BUILDING APPEAL BOARD AGENDA
Wednesday, January 10, 2024 – 3:00 p.m.
City Council Chambers, 3rd Floor of City Hall

1. Call Meeting to Order
2. Roll Call
3. Approve minutes of October 11, 2023
4. New Business: An Appeal of the Issuance of three Building Permits on November 27, 2023 dated December 18, 2023
 - a. Building Appeal Board Staff Report with Attachments
5. Adjournment

1. Objective – Provide an opinion on how the proposed Dragestil Hotel Development Project located at 723 South Lake Avenue in Duluth may impact adjacent landowners and the public.

2. Reference documents - Comments below are based on review of these design documents and CS&I comments.
 - a. Arola Architecture Studio Plans dated 5-19-23 numbered: Title, Site, A0.1, A0.2, A0.3, A0.4, A2.1-1, A2.1-3, A2.2, A2.3, A2.4, A3.1, A3.2, A4.1, A4.2, A5.1, A5.2, A6.0, A7.1, A7.2

Project	Dragestil Hotel - Opinion of Project Impact				
Subject	Site Photos (11-16-23)				
Project #	2301	By	Jeff Iisakka	Date	11-29-23
Sheet	2	Of	6

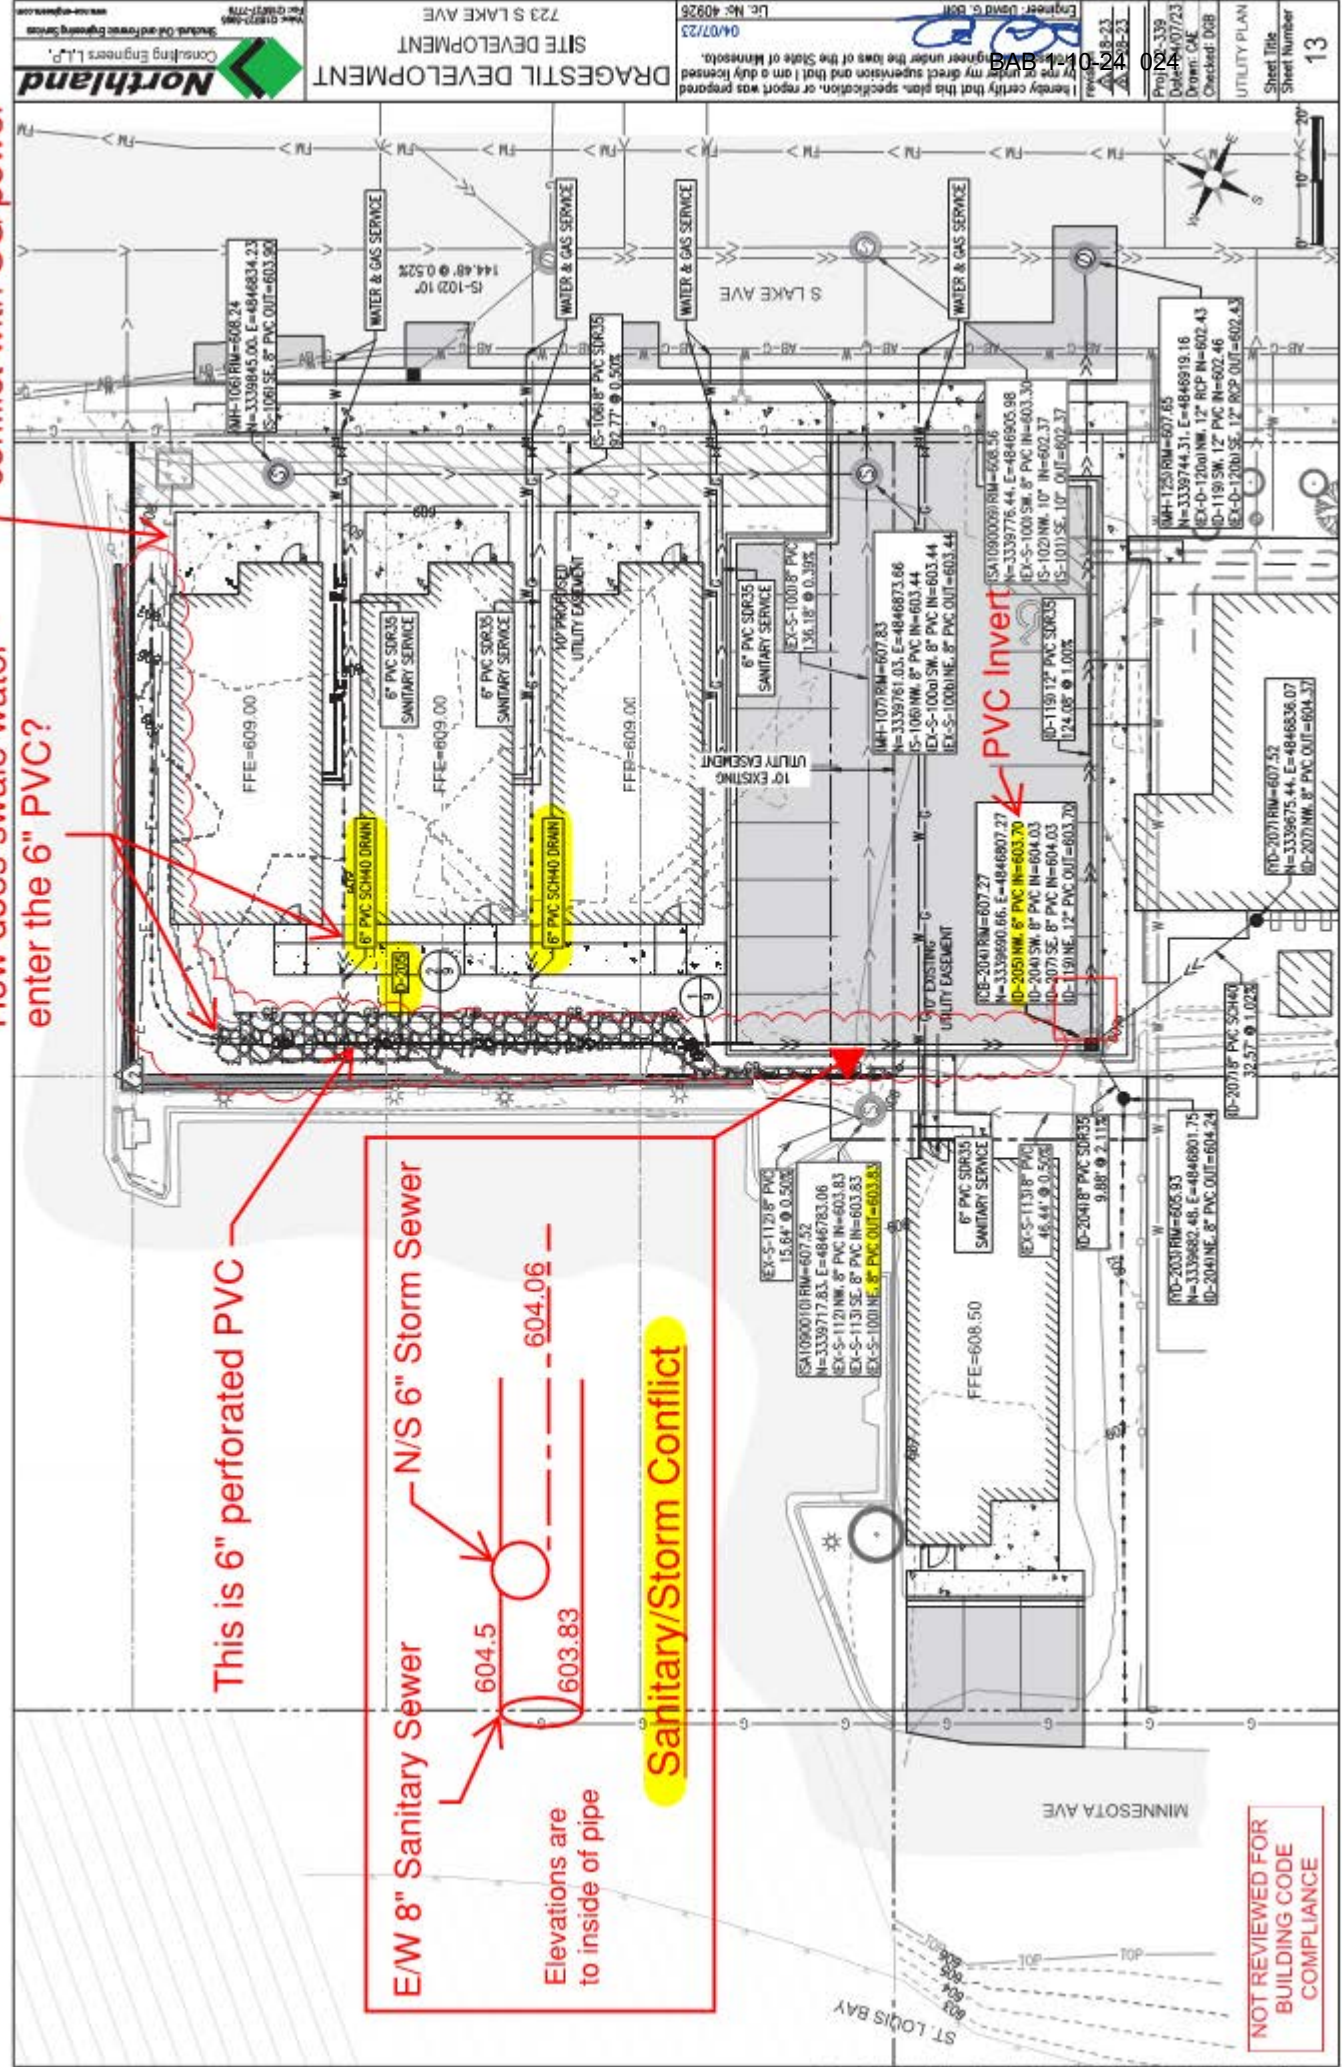
Building foundation may conflict with UG power

How does swale water enter the 6" PVC?

This is 6" perforated PVC

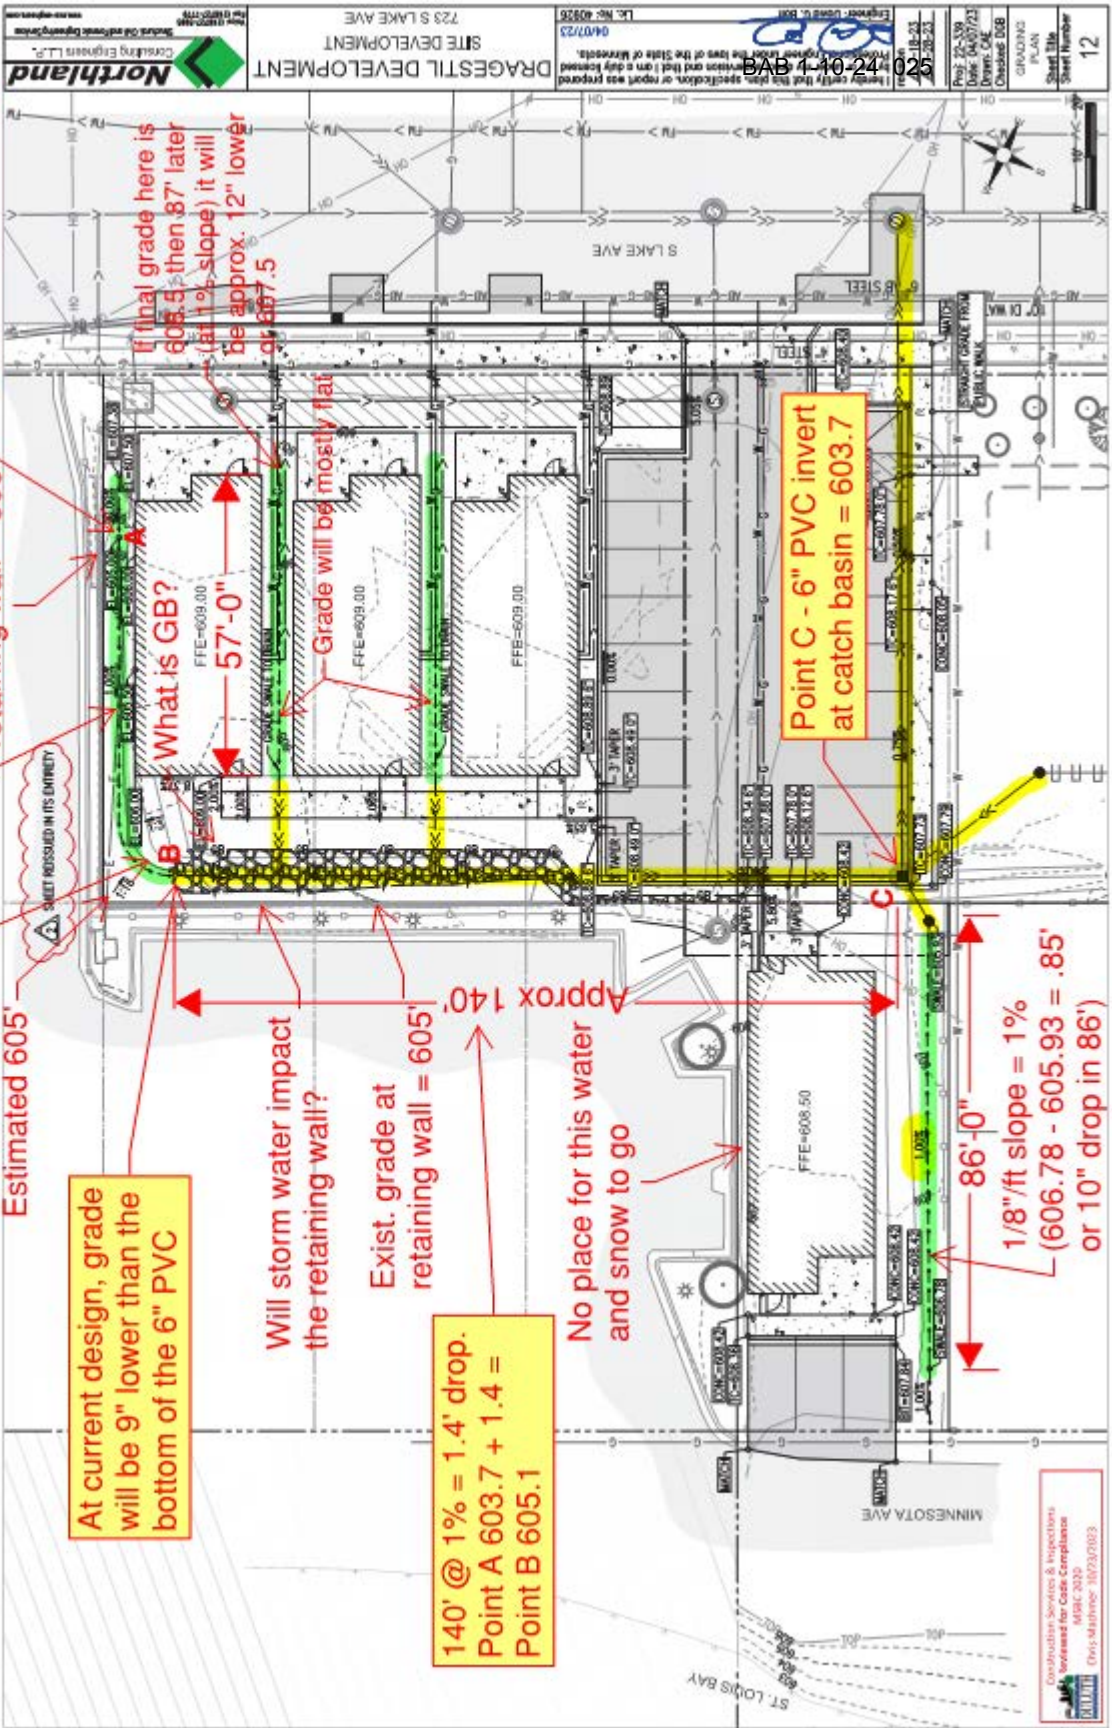
140' @ 1% = 1.4' drop.
Point A 603.7 + 1.4 =
Point B 605.1

No place for this water and snow to go

Point C - 6" PVC invert at catch basin = 603.7
